Sheet Title
GRADING & DRAINAGE PLAN
Drawn By: HTH & BJM Checked By: ES

Job Title
PROPOSED BUILDINGS FOR
SEGO LIMITED PARTNERSHIP
4811 HARDWARE DRIVE N.E.
ALBUQUERQUE, NEW MEXICO

HARDWARE BUSINESS PARK

HYDROLIC CALCULATIONS

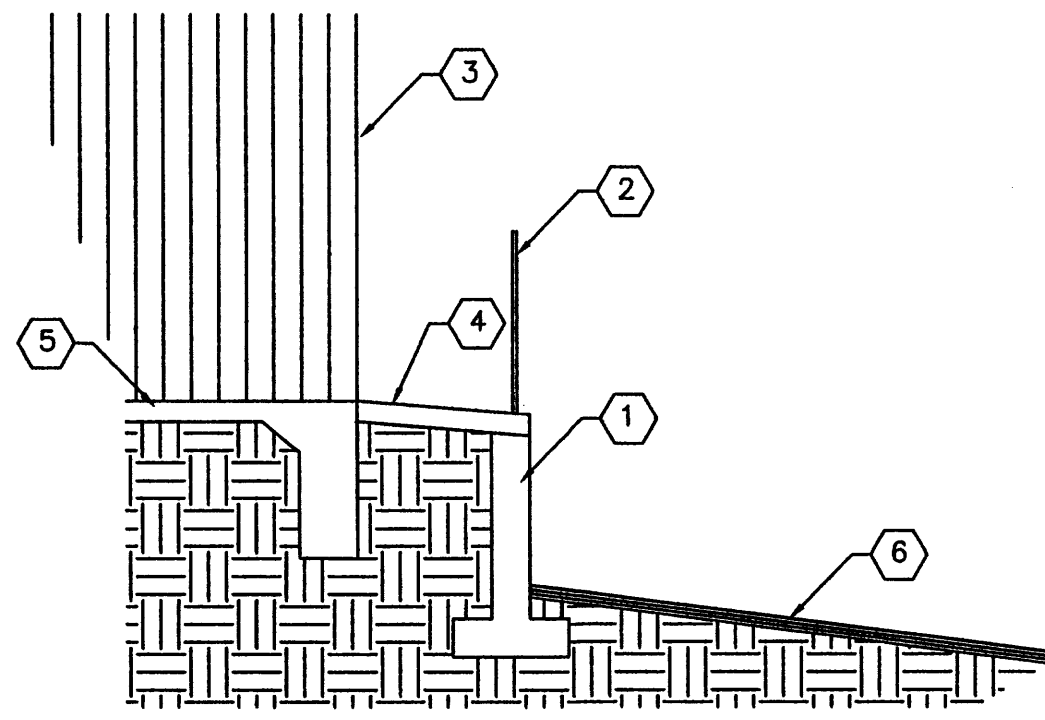
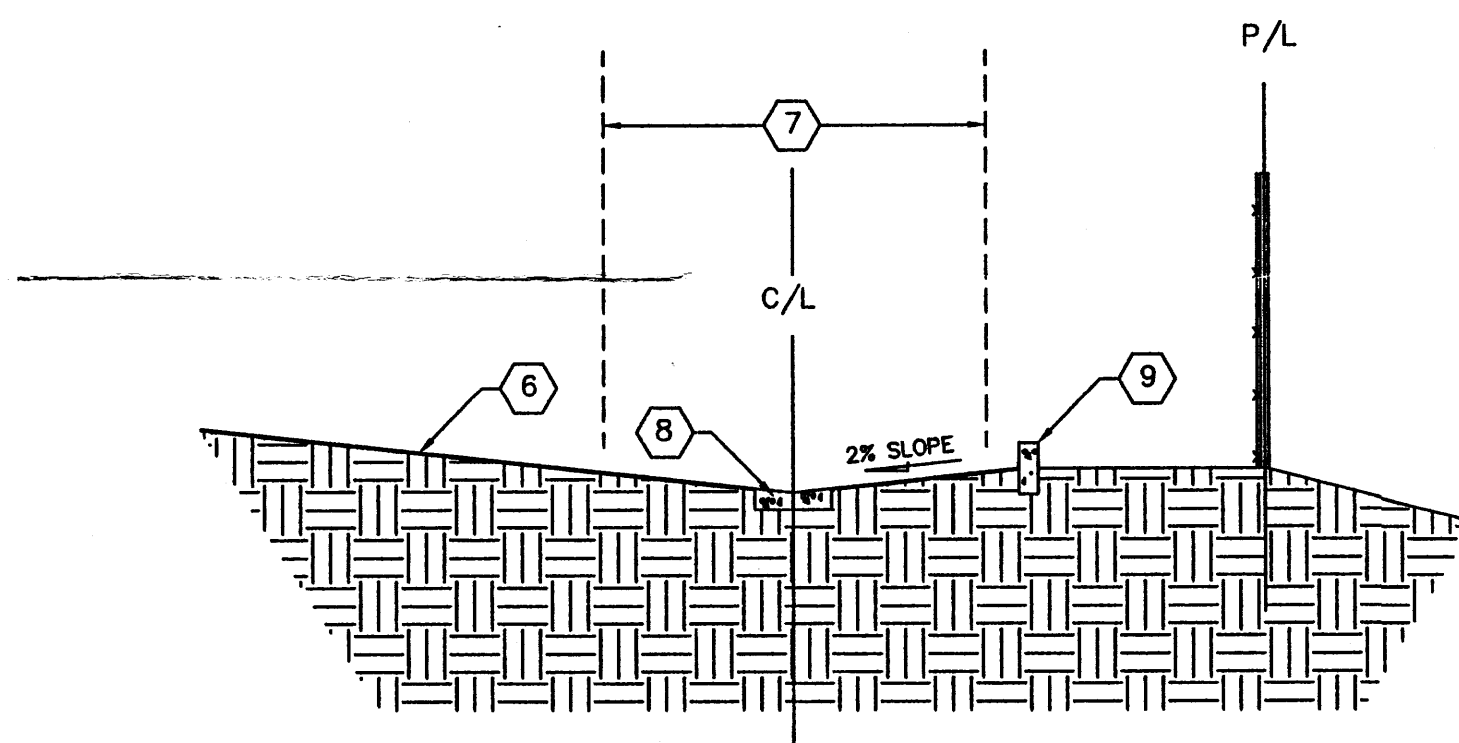
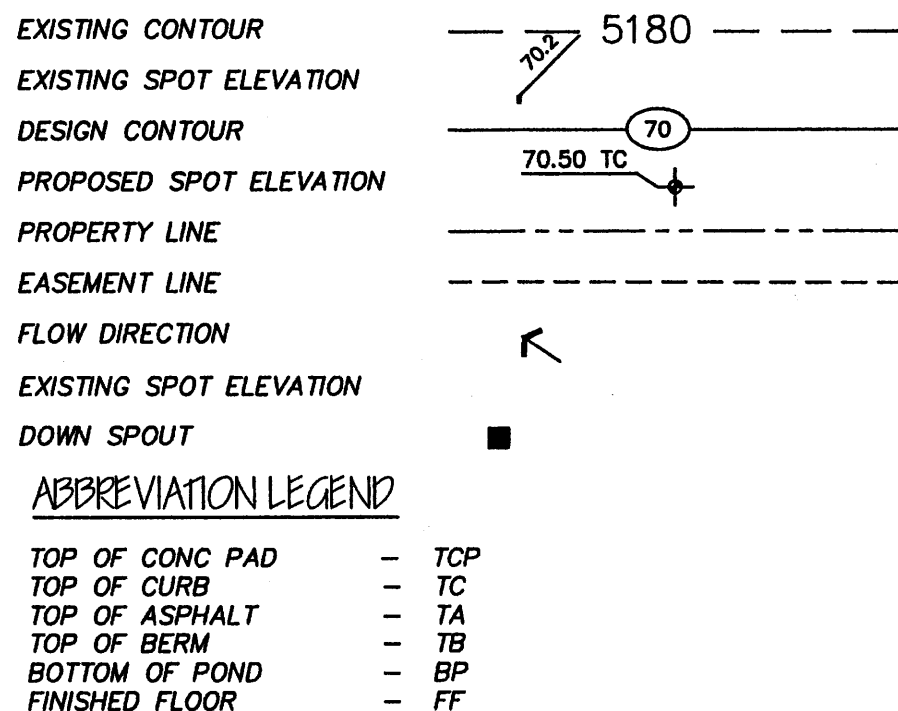
This is the proposed legal description
Must also include the existing legal description

GRADING & DRAINAGE PLAN

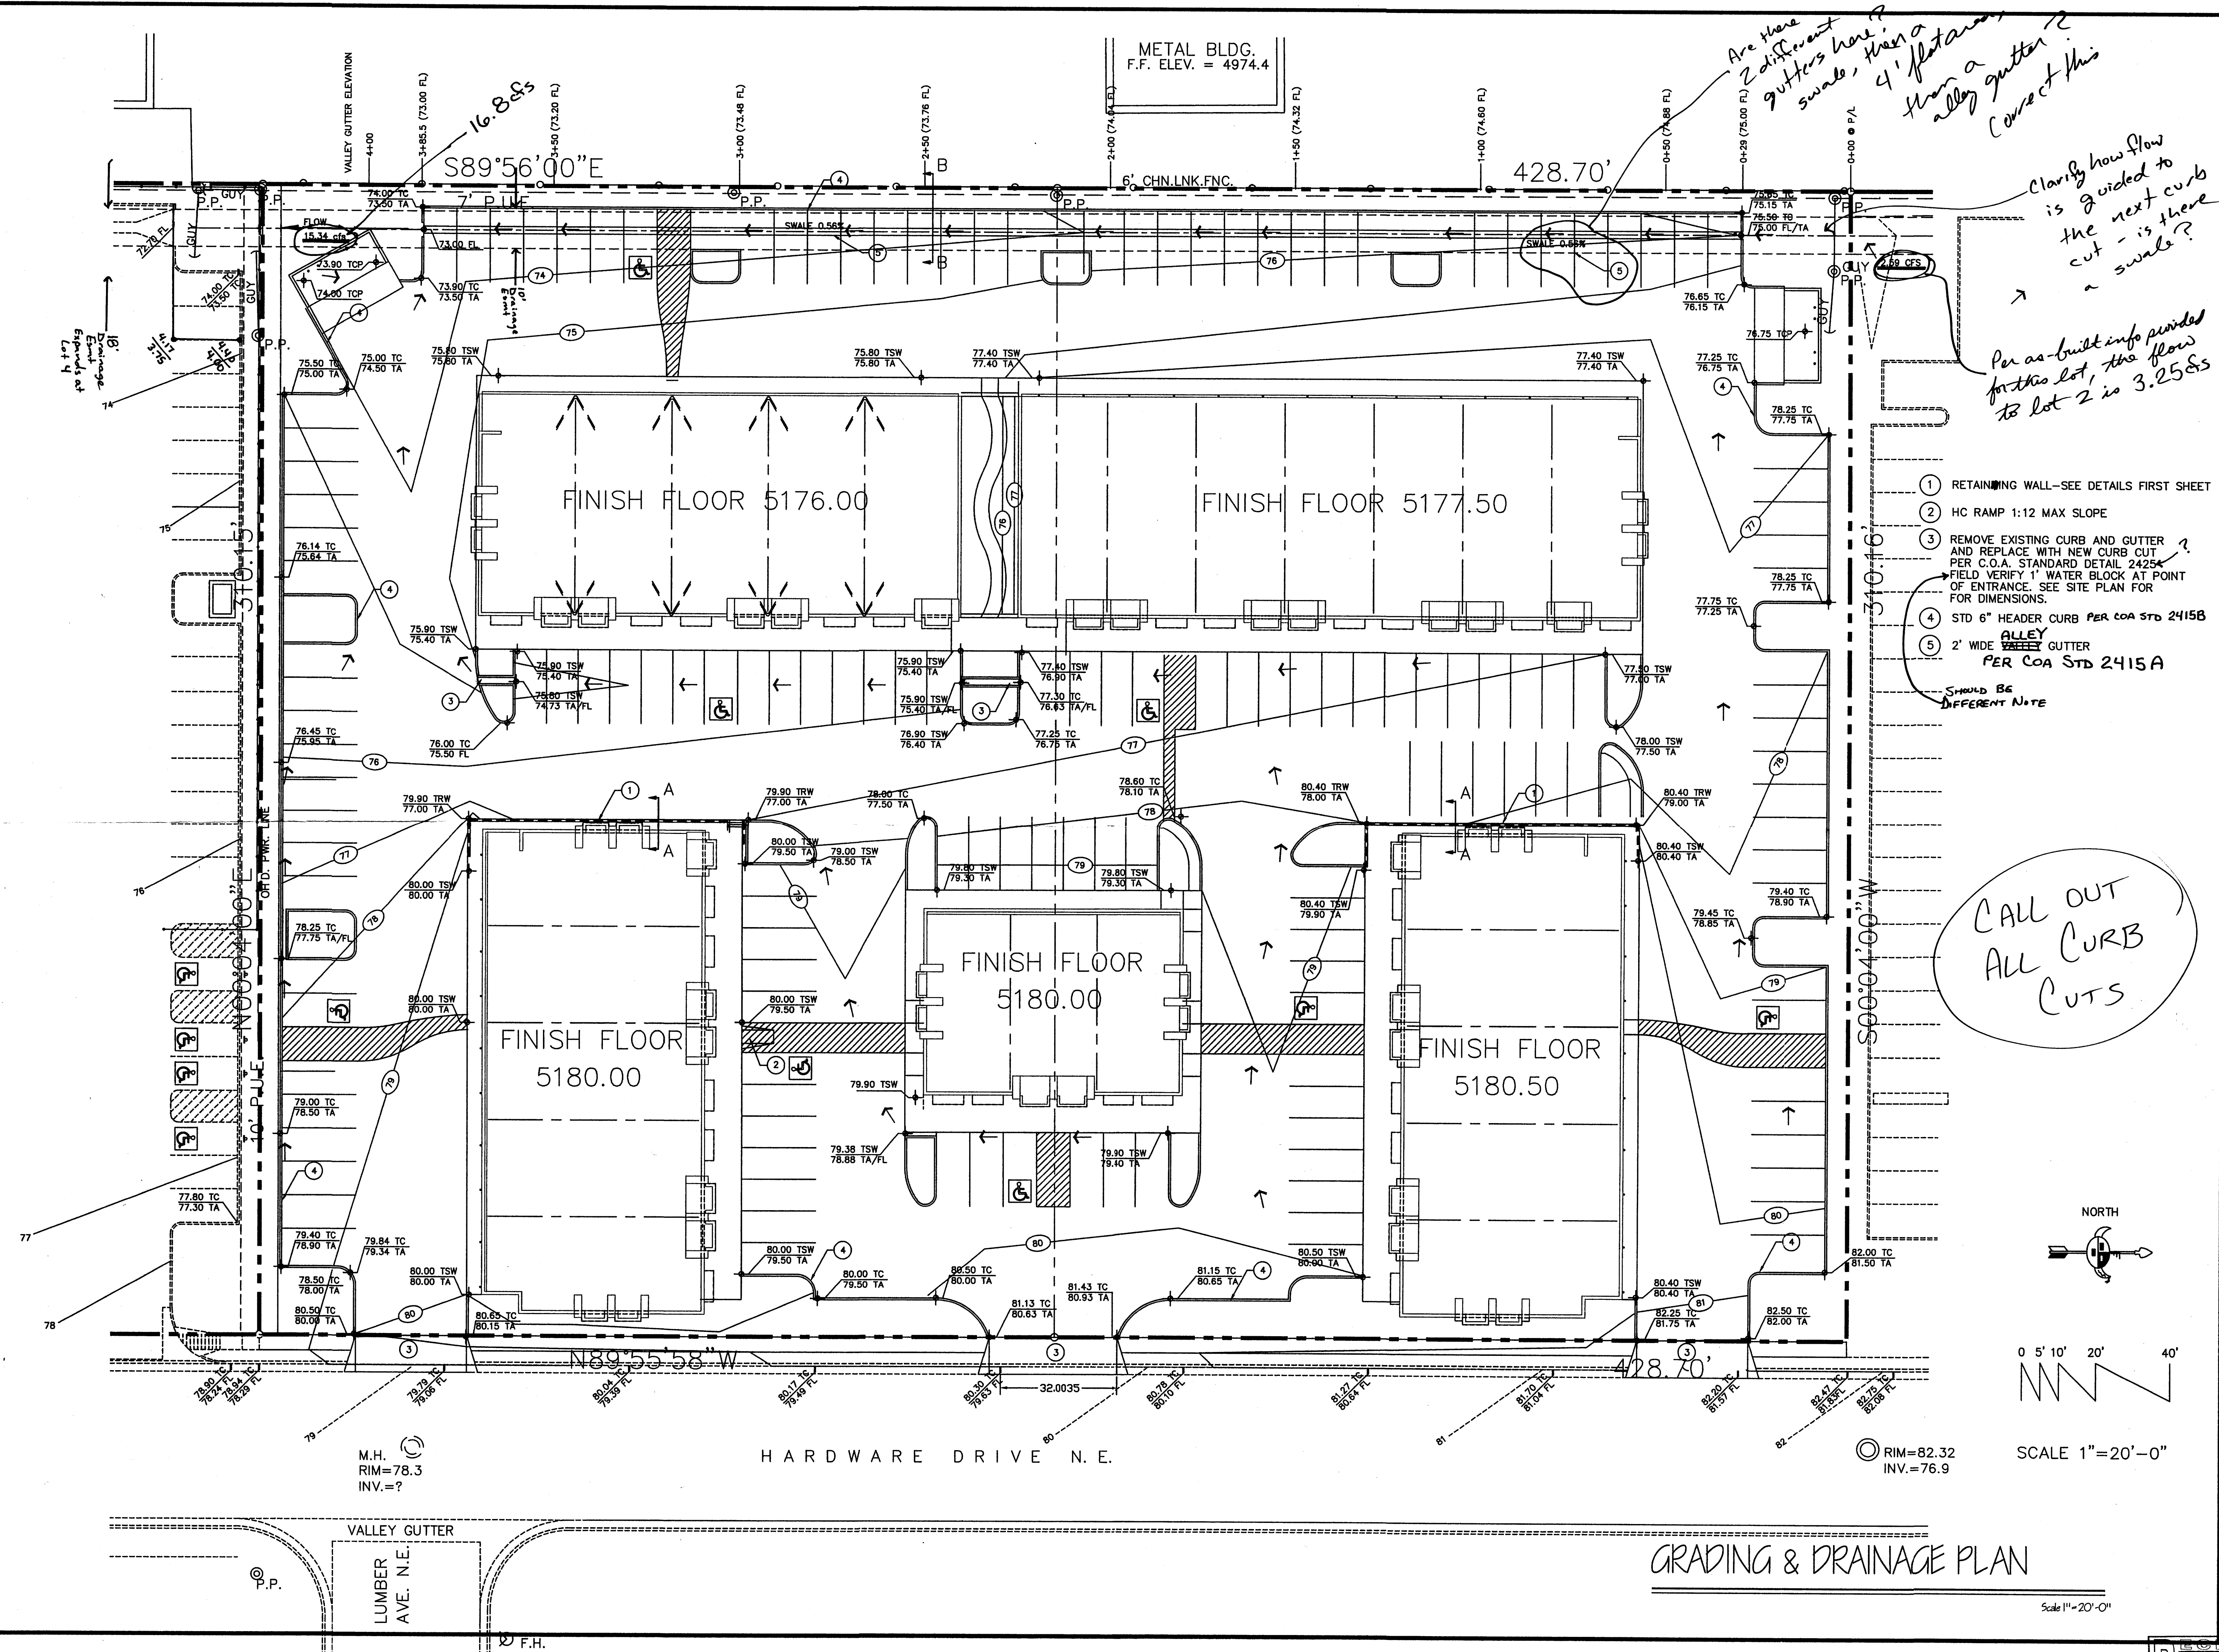
- 1 RETAINING WALL-SEE DETAILS FIRST SHEET
 - 2 HC RAMP 1:12 MAX SLOPE
 - 3 REMOVE EXISTING CURB AND GUTTER AND REPLACE WITH NEW CURB CUT PER C.O.A. STANDARD DETAIL 2425A. FIELD VERIFY 1' WATER BLOCK AT POINT OF ENTRANCE. SEE SITE PLAN FOR DIMENSIONS.
 - 4 STD 6" HEADER CURB PER COA STD 2415B
 - 5 2' WIDE ALLEY GUTTER PER COA STD 2415A
- SHOULD BE DIFFERENT NOTE

CALL OUT ALL CURB CUTS

Are there 2 different gutters here? swale, then a 4' flat area, then a valley gutter? Course of this

Clarify how flow is guided to the next curb cut - is there a swale?

Per as-built info provided for this lot, the flow to lot 2 is 3.25Ss
